Historic Preservation Design Review

HP-10-03, 30 N. Main St. (City)

Request: Design Review for proposed rear windows and other work to the rear elevation

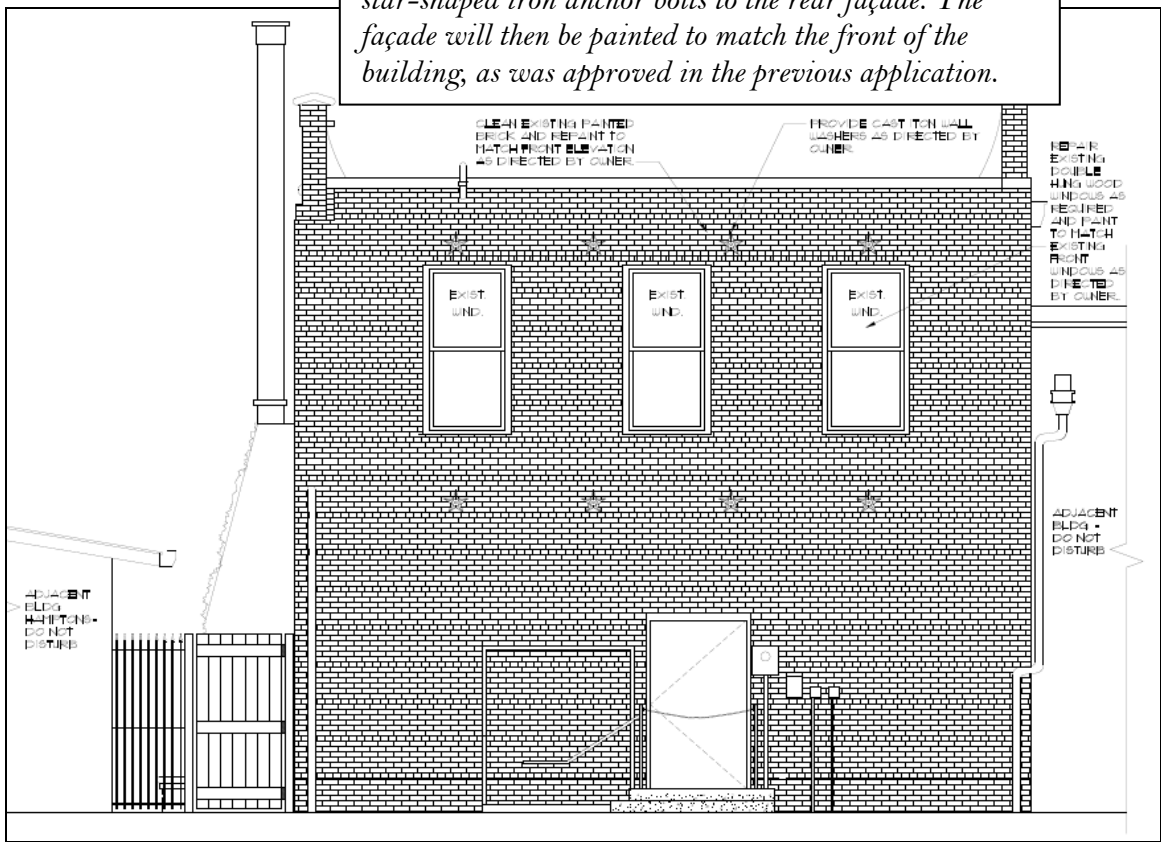
There is no architectural evidence of windows at the rear of the building as it stands today. The rear wall is a roof-to-ground veneer, and any residual framing or sills from the original windows that were located in this façade are not present.

Interior photos of the upper story show the existing window area. A close-up of one of these is shown in the photo to the right.

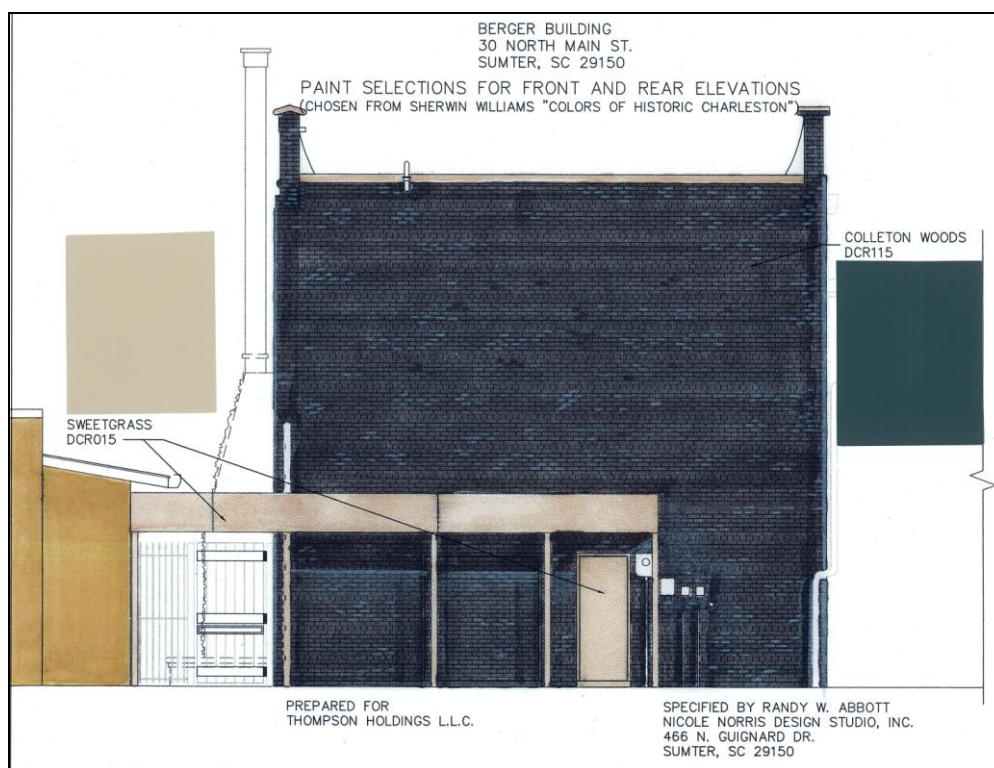
The proposal is to add windows, stabilizing bars, and star-shaped iron anchor bolts to the rear façade. The façade will then be painted to match the front of the building, as was approved in the previous application.

The present request is to replace three windows on the second story at the rear, at the location of the existing window areas that have been covered up by brick veneer, with replacement windows that will match those on the front of the building.

The windows will be placed in wooden frames in the same manner as the ones at the front of the building, in order to fit them into the openings and so that the windows are supported properly.

In addition, eight (8) metal star-shaped anchor bolts are proposed as structural support elements above and below these windows, which will hold stabilizing rods that will go through the walls. A copy of these plans is shown on the previous page.

The proposed replacement windows on the rear elevation will match the windows on the front of the building which were previously approved and are in keeping with what was there originally. They will be placed in the original locations. The sills and brick surrounds will be in accordance with what is appropriate on a rear elevation for a historic commercial structure, and will be similar to what is around the windows on the front of the building.
